FIG. 3B

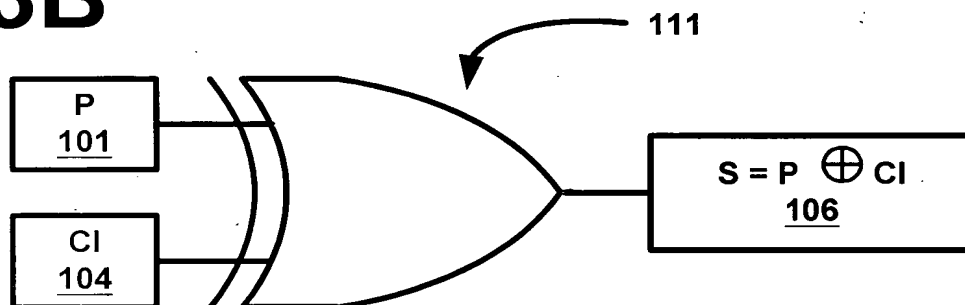
The drawings stand objected to because a label appearing in FIG. 3(b) does not correspond to the written description. In this regard, Applicant submits herewith a corrected sheet of drawings, which includes a revised FIG. 3(b), and respectfully asserts that the rejection has been accommodated. Specifically, Applicant has corrected FIG. 3(b) to properly depict that the carry in signal CI 104 is exclusively "OR"ed with the P signal 101 using the logical exclusive "OR" circuit 112 (*see* specification page 7, lines 21 – 22).
